# Board of Adjustments regular meeting

December 17, 2019 at 5:00p.m.

**SUBJ:** STUBBS VARIANCE REQUEST, 2661 VIA TUSCANY

**SUBJECT:** Cichra/Mondrian VARIANCE REQUEST, Mondrian Circle (Formerly 1800 Lee Road)

### SITE PLAN

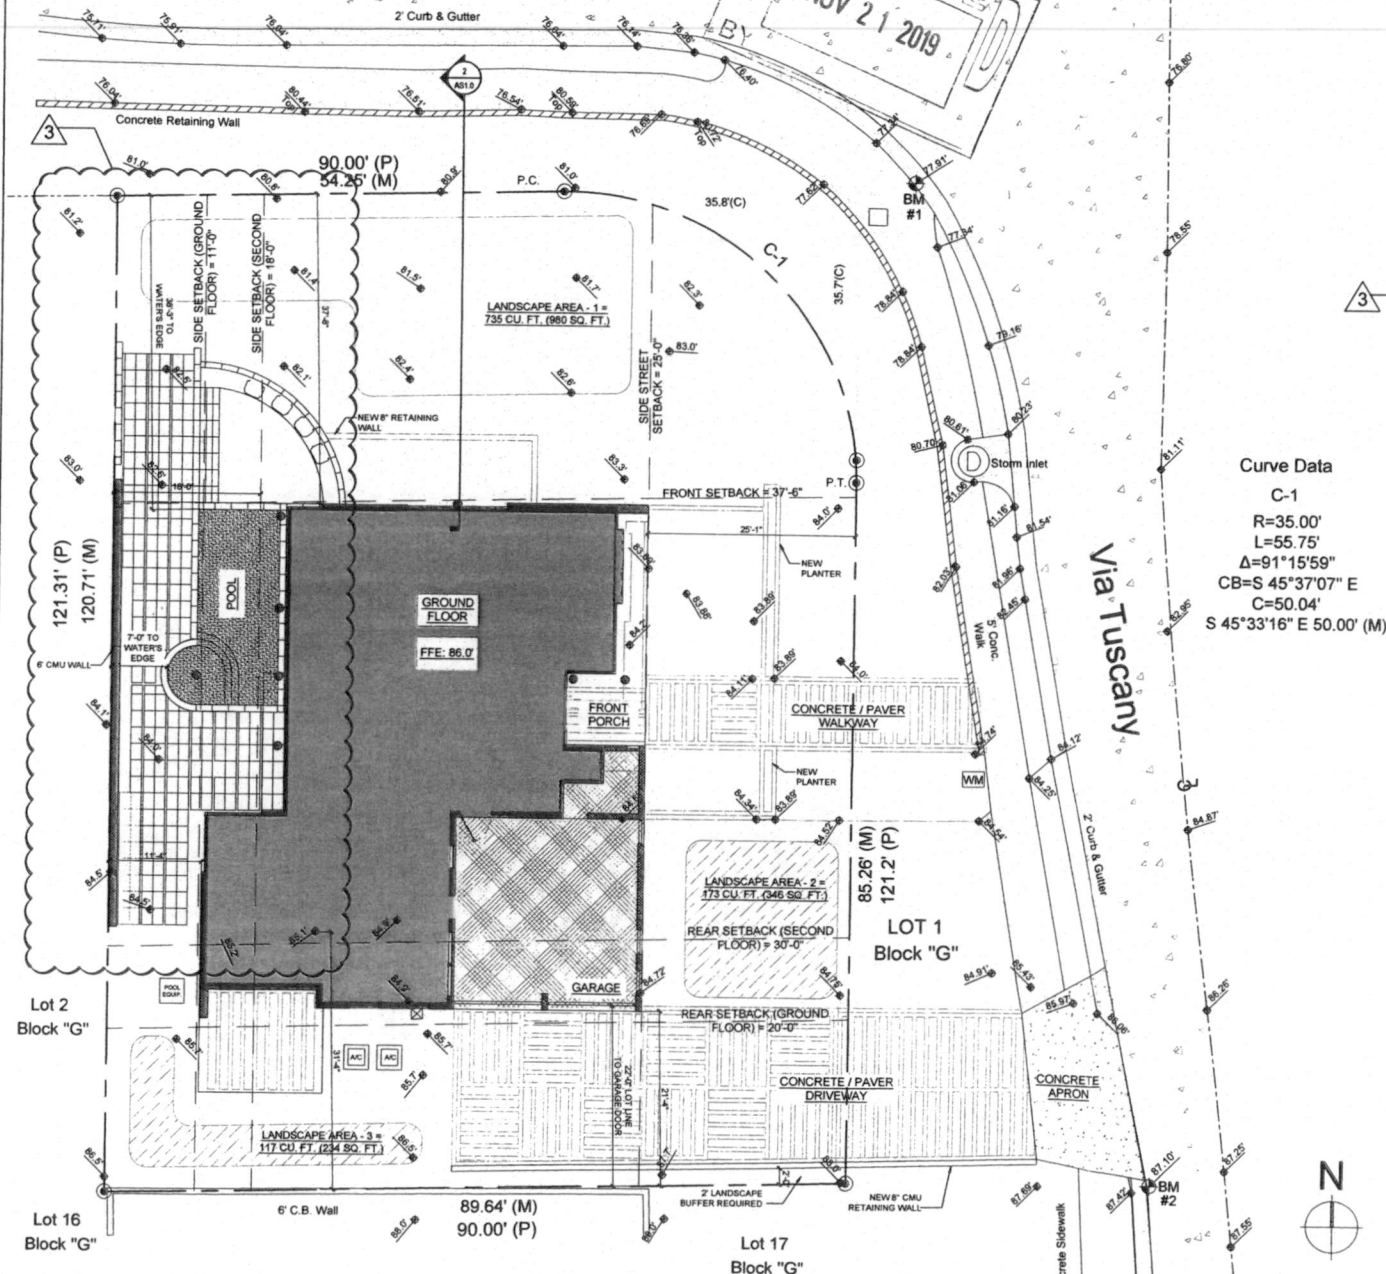
The applicant has revised the previously tabled request to show the proposed construction of a swimming pool and deck located 7 feet and at one point 8" feet from the west side lot line, whereas the required side setbacks are 10 feet and 5 feet respectively. This removes any portion of the pool from the required front yard setback area as originally requested, leaving only side setback encroachments to the pool and pool deck location.

Revised plans (included in this packet) have been submitted reflecting the changes made to the pool and deck location on the property, except for one needed revision should this variance be granted. A portion of the pool deck on the west side of the lot next to the wall will need to reflect a 2 foot side setback.

SPECIAL PURPOSE SURVEY  
PROPOSED DOCK LOCATION  
THE MONDRIAN

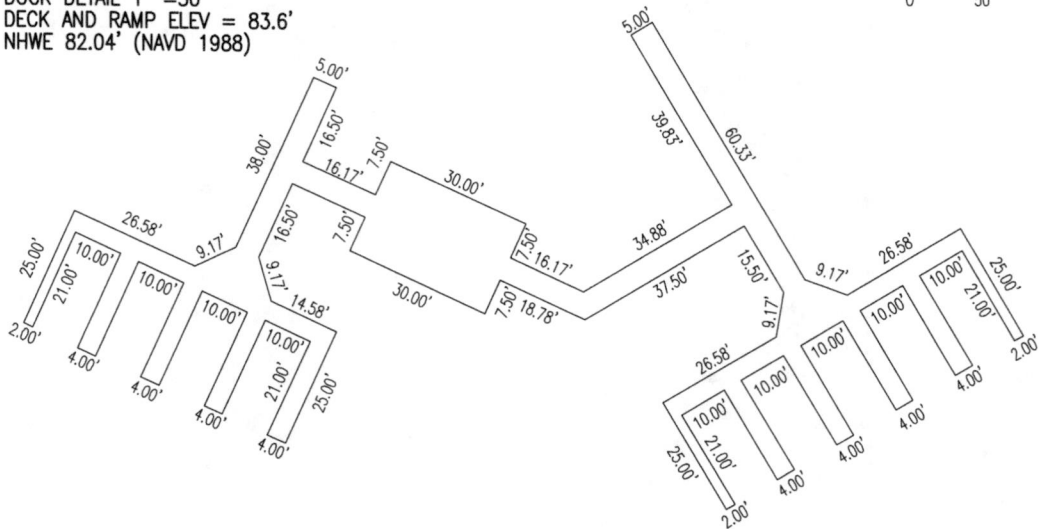
The proposed dock on the east side has 5 boat slips and projects 40 feet into the Lake, and the west dock has 6 boat slips and projects out 41 feet. Lake Killarney has very shallow shorelines and our Zoning Code was amended to those allow those docks to extend out to 50 feet. In addition the proposed walkways and deck area abutting the lake are within the allowable to allow 10% coverage limitation permitted for accessory deck/walkway structures on lakefront properties.

- The boat slips were too short in the opinion of the board and they asked that they be lengthened without increasing the length that the docks extended into the lake. To do this the "T" sections of the dock were moved landward to allow the slips to be at least 21' long.
- The docks (I don't recall if it was one or both) were moved away from the tip of the point to reduce the amount of the strait would be impacted by the docks.

The current plans show significant extensions of 40' and 41' out into the water, with the stated reasoning being bridges extending over wetlands and further extension needed to provide enough depth for boats. I find this point confusing as most of the other properties around the cove, mine included, have accommodations for boats which are all significantly closer to shore with no depth issues encountered. My own boat is positioned about 4' from shore and has ample depth to operate. Additionally, newly constructed boathouses on Country Club Dr. are also similarly tight against the shoreline. Nowhere around our cove portion of the lake is any dock/boathouse that extends anywhere near the proposed distance.

**BOATHOUSE SITE PLAN  
2072 VENETIAN WAY  
WINTER PARK, FL 32789**

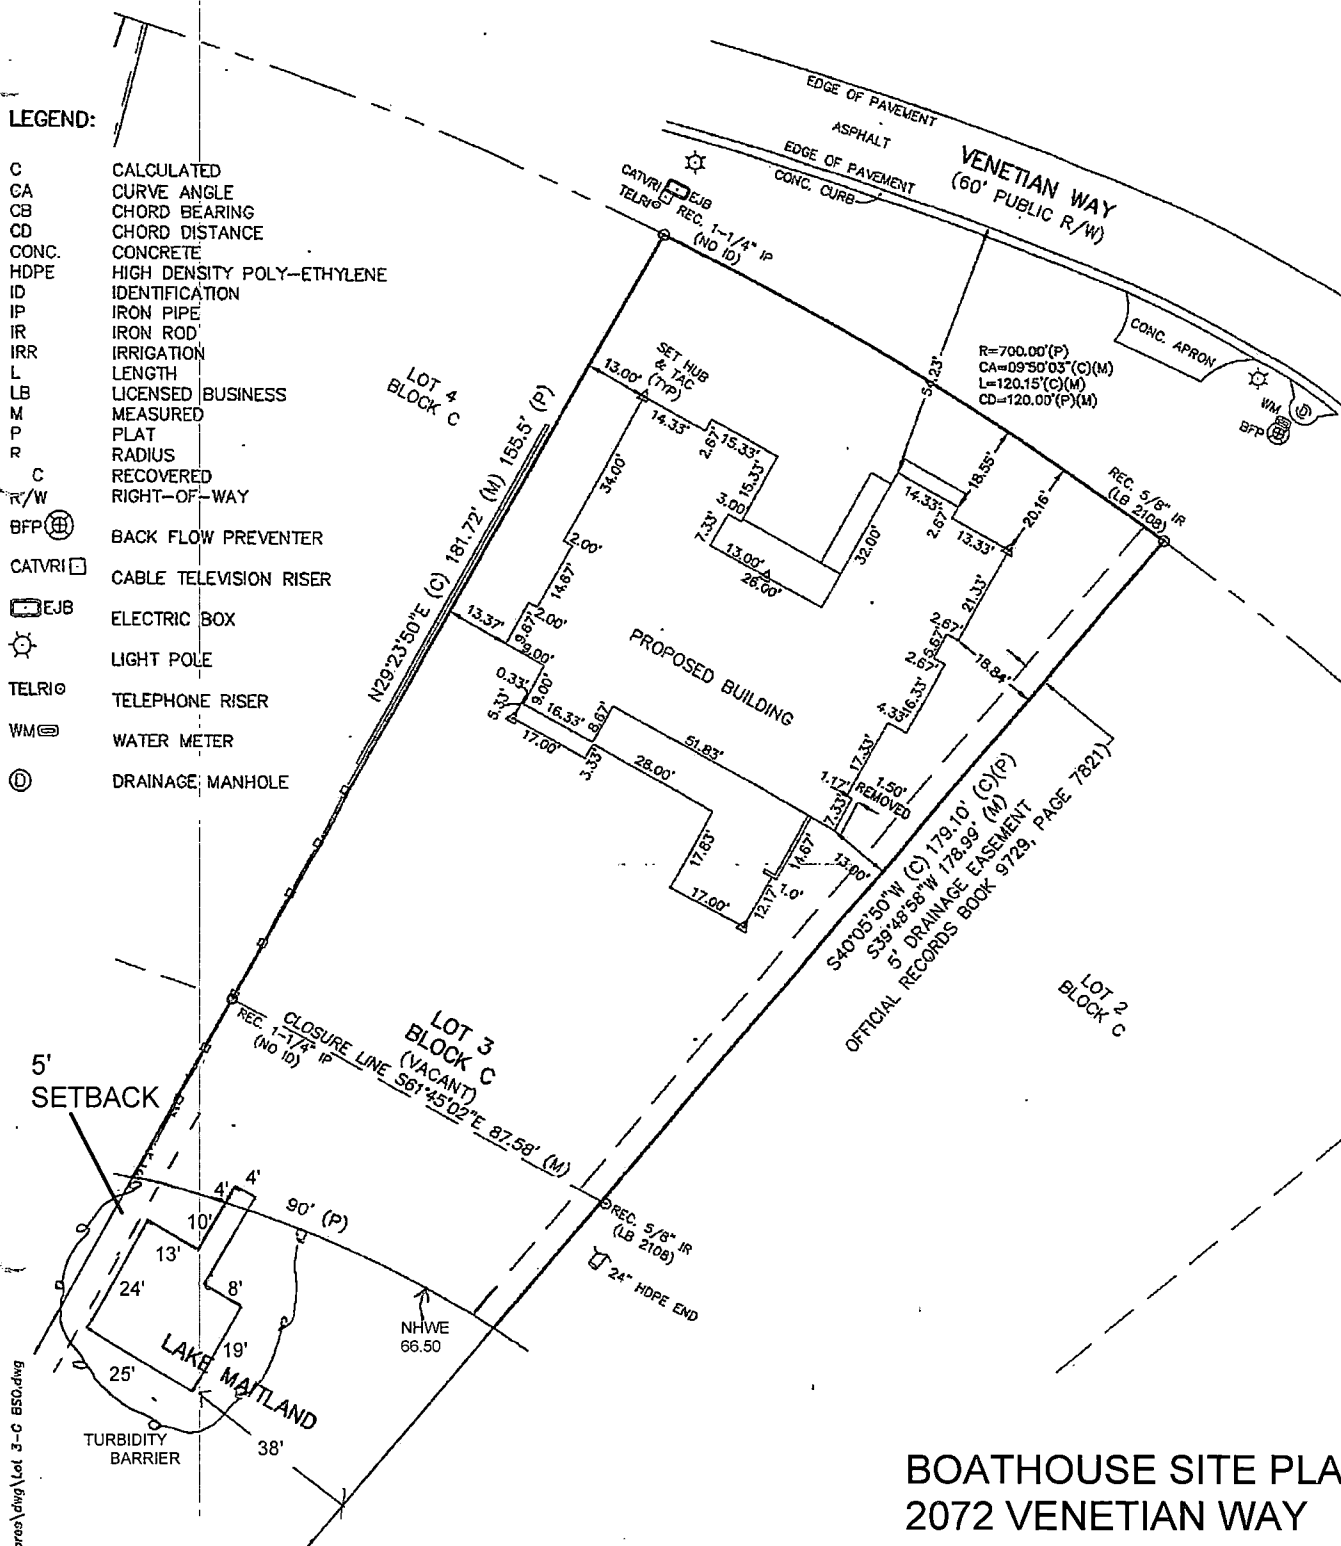
The applicant will be providing details on water depth measurement prior to or at the meeting to verify the need to extend the rebuilt boathouse the requested 4 feet in length.

In addition, the applicant has include a necessary letter of approval from the adjacent property owner to allow a continuation of the 5 foot side setback in lieu of having to move the new boathouse to a 10 foot side setback. The adjacent neighbor's boathouse appears to also be located at a 5 foot side setback from the common lot line between these properties. The Planning and Zoning Board, the Lakes Board and staff have encourage locating boathouses adjacent to the common lot line on lakefront properties to enhance views to the lake.
